**STANADYNE**  
Diesel Systems**SERVICE BULLETIN**LIMITED  
DISTRIBUTION

**LIMITED DISTRIBUTION - NAVISTAR INTERNATIONAL****SUBJECT: MECHANICAL SHUTOFF KIT FOR NAVISTAR  
6.9 AND 7.3L SCHOOL BUS APPLICATIONS**

**MECHANICAL SHUTOFF  
KIT 26046****Figure 1**

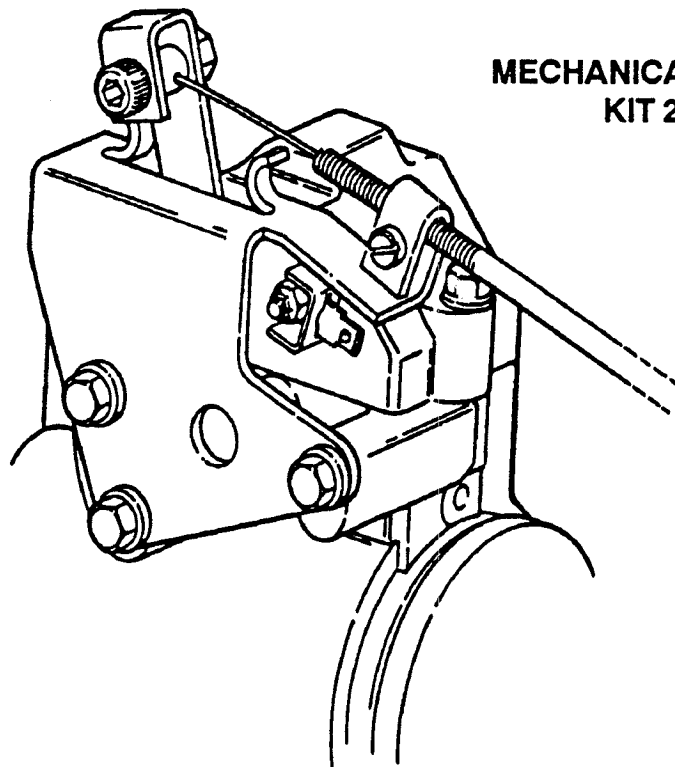
This mechanical shutoff device replaces the standard electrical shutoff solenoid and enables the operator to shut down the engine through the use of a dashboard mounted control knob and cable attached directly to a control lever on the fuel injection pump governor cover. (Figure 1)

Figure 2

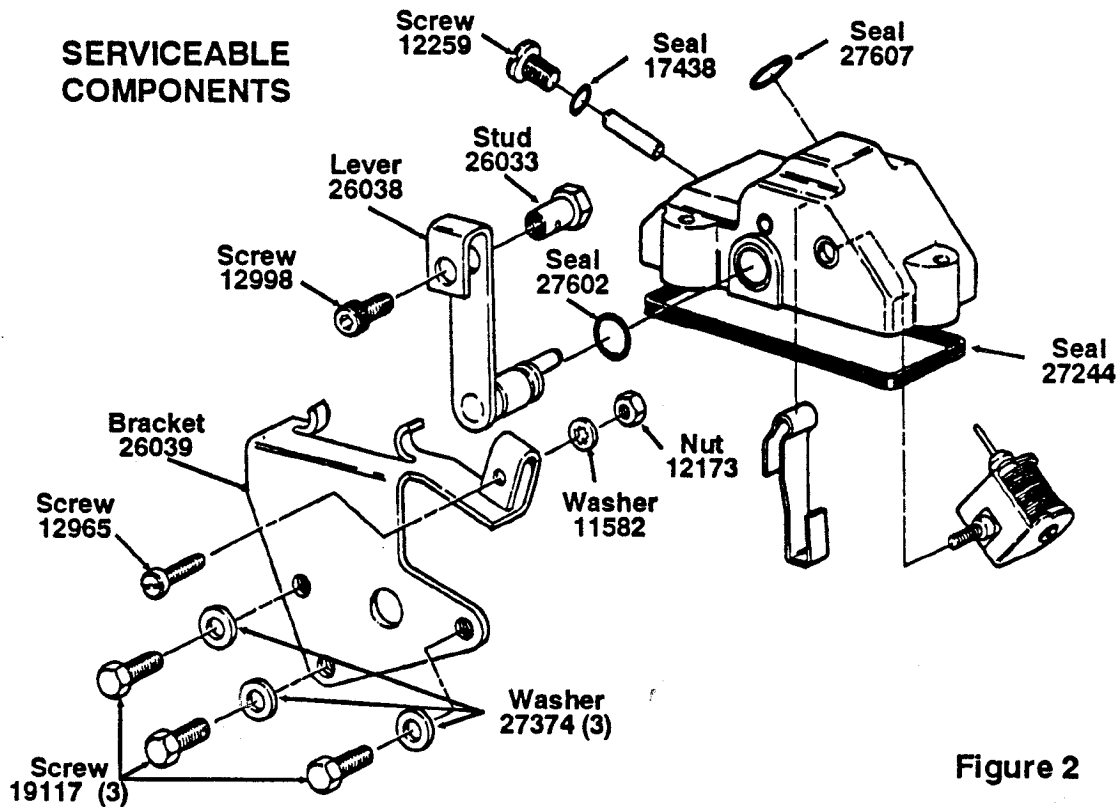
An exploded view of the assembly is shown below (Figure 2) with all serviceable components identified for repair purposes. Should any non-serviceable components be required such as the governor cover assembly, then a complete kit must be ordered.
